TECHNICAL SERVICE BULLETIN: 104750-000

Beechcraft Series 36 Autopilot Servo Update, Rev A

This Document Supersedes: 104686-000 Beechcraft Series 36 Yaw Servo Cable Misalignment

Figure 1: Before/After Implementing the Yaw Servo Cable Misalignment Fix

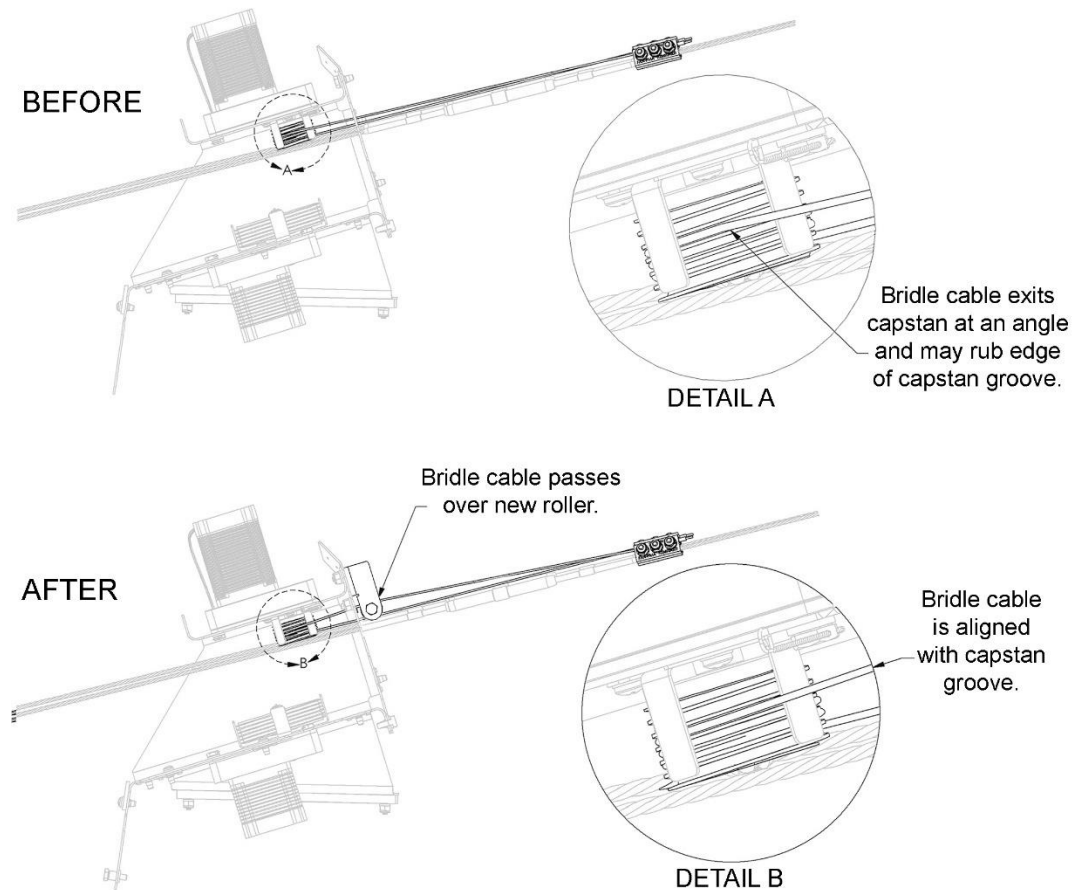
Dynon has received reports of Beechcraft Series 36 aircraft where the yaw servo bridle cable on one side of the capstan is misaligned by a few degrees (see [Figure 1](#)). Over time, this misalignment could lead to wear on the capstan's grooves. This bulletin details the fix (see [Figure 1](#)) for the misalignment.

Figure 2: Before/After Implementing Bracket Assembly Brace Attachment Fix

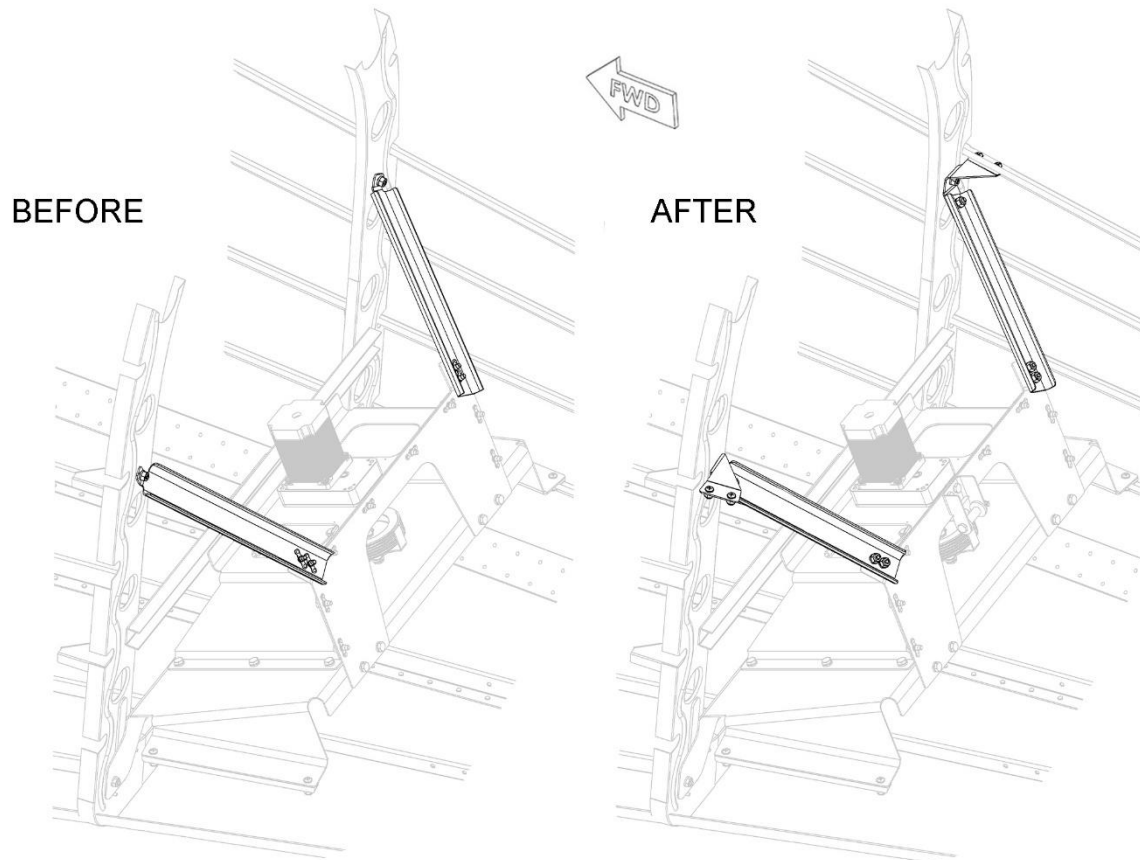
Dynon learned that existing pitch/yaw servo bracketry installations in Beechcraft Series 36 aircraft may introduce higher loads into aircraft structure at bulkhead FS207 than originally calculated. However, Dynon has received no reports of failure or damage in this area occurring in the field. This bulletin details a fix (see [Figure 2](#)) to prevent any potential issues in this area.
